18 December 2019

Draft flood studies for the Sandy Creek, Rocky Dam Creek (Koumala) and Funnel Creek (Sarina Range) catchments

Peak Flood Depth 1% AEP Event – 18 Hour Storm - Rosella

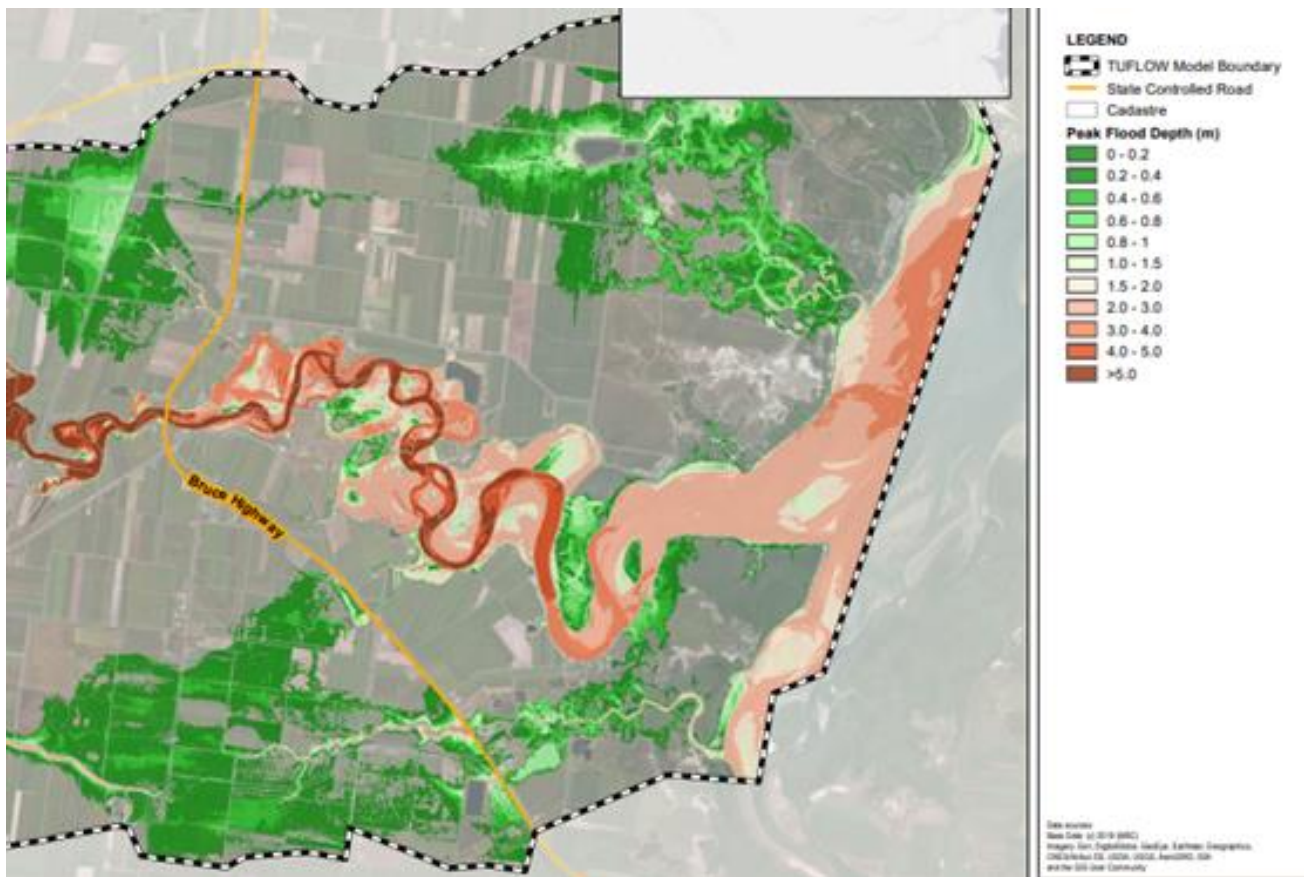
We have extracted below one of the maps from the Sandy Creek Catchment draft report which shows the possible 1% AEP Event impact on the southern portion for the Rosella State Industrial Precinct. The Institute is concerned that filling in this precinct may be restricted unnecessarily as a consequence of the report. The modelled flooding appears to be a fairly minor (comprising backwater) at around 0.3m to 0.4m. This finding should be checked and appropriate resolutions to allow for development should be defined as part of the report.

We also note the Bruce Highway crosses the northern boundary of the study area, at approximately the location of the Rosella Store i.e. intersection of the Bruce Highway and Homebush Road and should be considered in the report.
